## CHRONOLOGY OF NORTH RILDA CANYON PORTAL FACILITIES

## CHRONOLOGY OF NORTH RILDA CANYON PORTAL FACILITIES

The following responses to deficiencies are formatted as found in the technical analysis document. They are broken down into logical section headings similar to the R645 regulations. In each section, the regulation number along with the associated deficiency is followed by the permittee's italicized response.

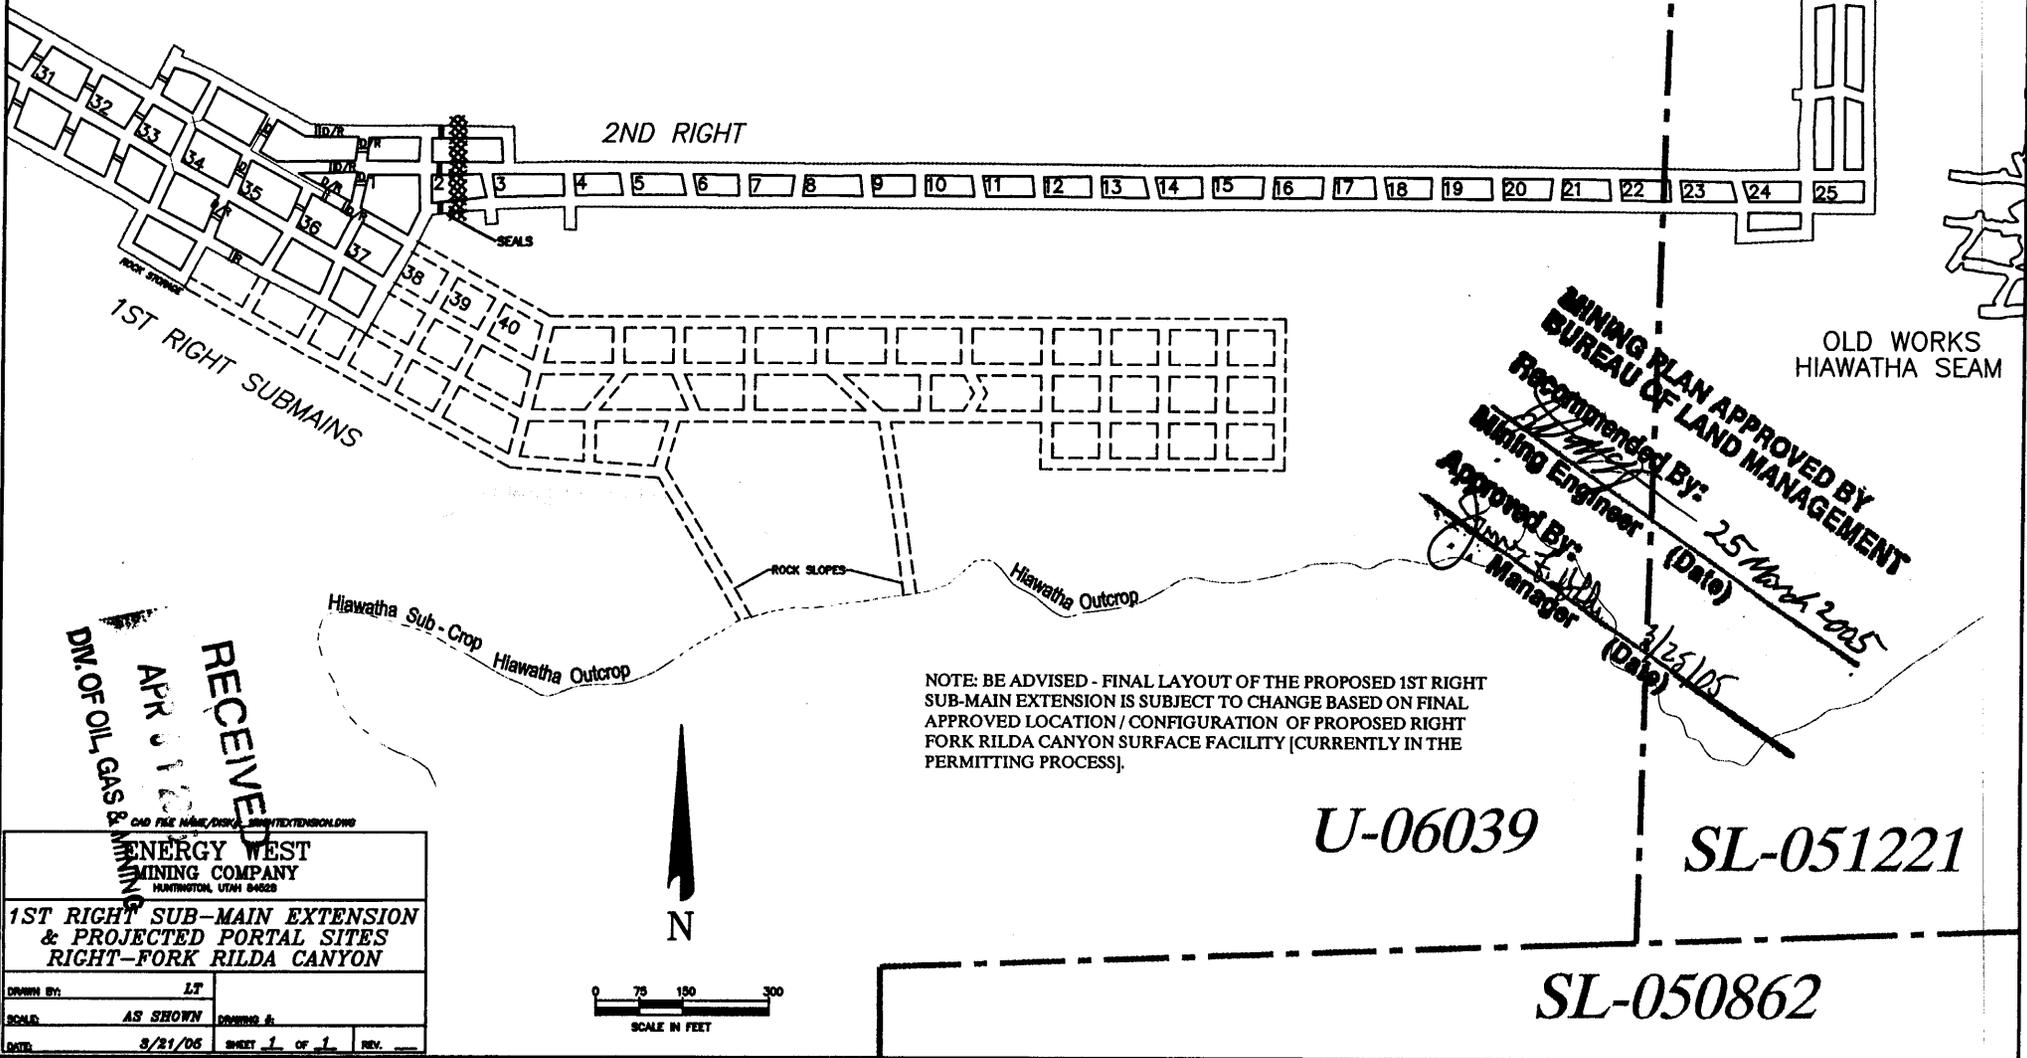
PacifiCorp proposes to drive entries to access ventilation portal sites as shown on the attached mine map "1<sup>st</sup> Right Sub-Main Extension & Projected Portal Sites Right-Fork Rilda Canyon." BLM understands this plan is based on extensive underground drilling to better define the geologic conditions, including the areas of naturally burned coal (map attached showing extent of underground drilling).

BLM approves development mining of the 1<sup>st</sup> Right Sub-Mains Extension with the planned rock slopes as shown. Should it become necessary to alter this configuration, PacifiCorp is required to consult with BLM and further modifications could be necessary. Should PacifiCorp store rock

The modification to the R2P2, as depicted on mine map "1<sup>st</sup> Right Sub-Main Extension & Projected Portal Sites Right-Fork Rilda Canyon" is approved, contingent on the requirements stated above and pending State Permit approval. A copy of the approved mine map is enclosed. If you have any questions, please contact Jeff McKenzie of my staff at (801) 539-4038.
